CONSTRUCTION DRAWINGS  
FOR  
THE ESTATES AT  
ROLLING HILLS RANCH FILING 2  
IMPROVEMENT PLANS  
PREPARED FOR GTL, INC. DBA GTL DEVELOPMENT, INC.

PCD Filing No.:  
SF-20-018

THE ESTATES AT  
ROLLING HILLS RANCH FILING 2  
STREET AND UTILITY PLANS

DESIGN ENGINEER'S STATEMENT:

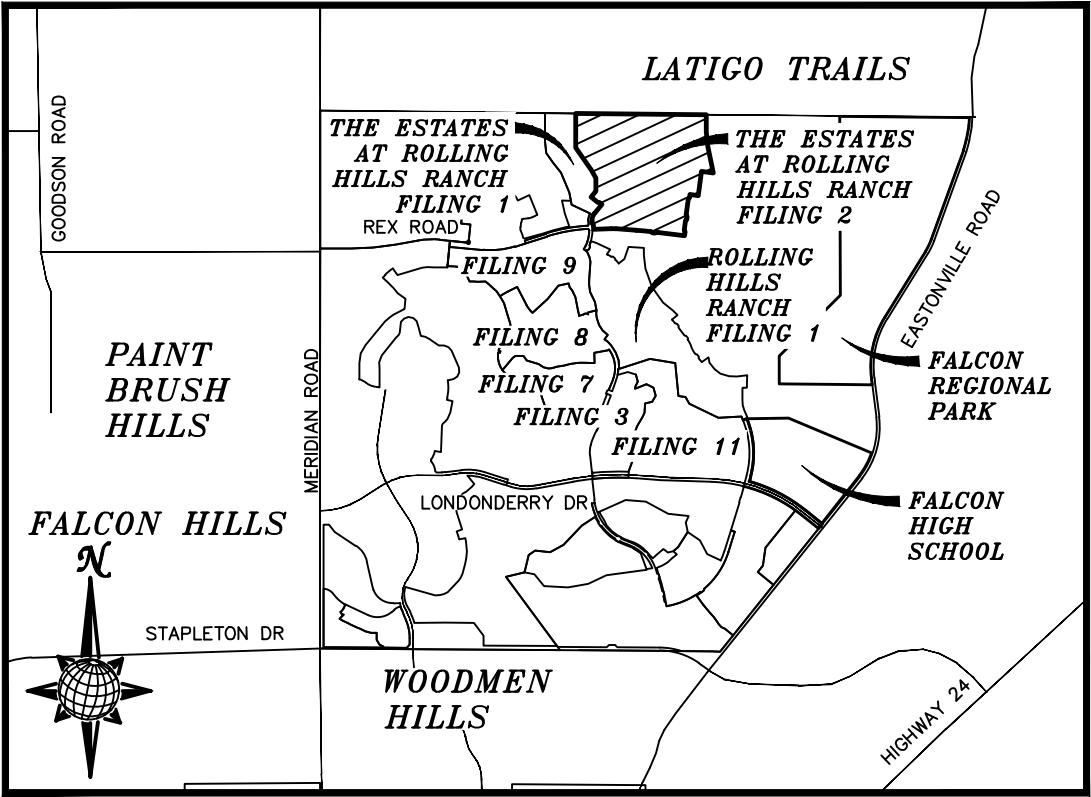
Add lines for signature and date
